Issue with one entry in
Table 15.4-1

Table 15.4-1
“Similar” Nonbuilding Structure Options
Steel Ordinary Concentrically Braced Frames

A- Concentric Brace

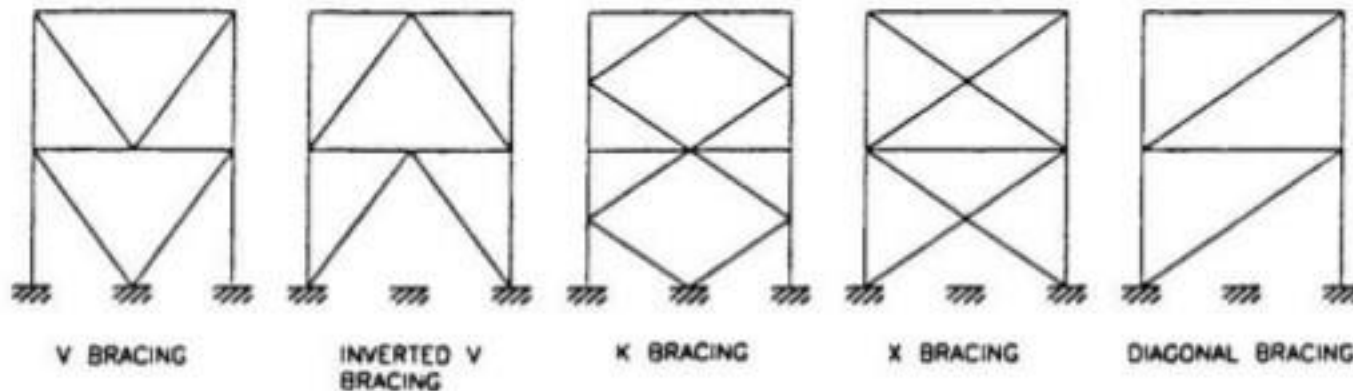
- For larger industrial structures (higher than 35 feet), some cost-conscious nonbuilding structure design engineers are using the not detailed OCBFs with $R = 1.5$ and higher member and foundation forces rather than using a seismic detailed OCBFs per AISC 341 with $R = 2.5$ because the connection forces are lower (e.g. 67 bolts rather than 80 bolts per connection). **This was not intended.**

- There is no real basis for the omega zero value of 2 to be used with an $R = 2.5$. I just kept the same as the omega zero value to be used with $R = 3.25$ back when was this option was proposed for inclusion the 2003 NEHRP.

- My suggested solution is to reduce the value of omega zero to be used an $R = 2.5$ to value of 1.7 or less (perhaps as low as 1.5) so there will be no direct incentive to use the not detailed for seismic option.
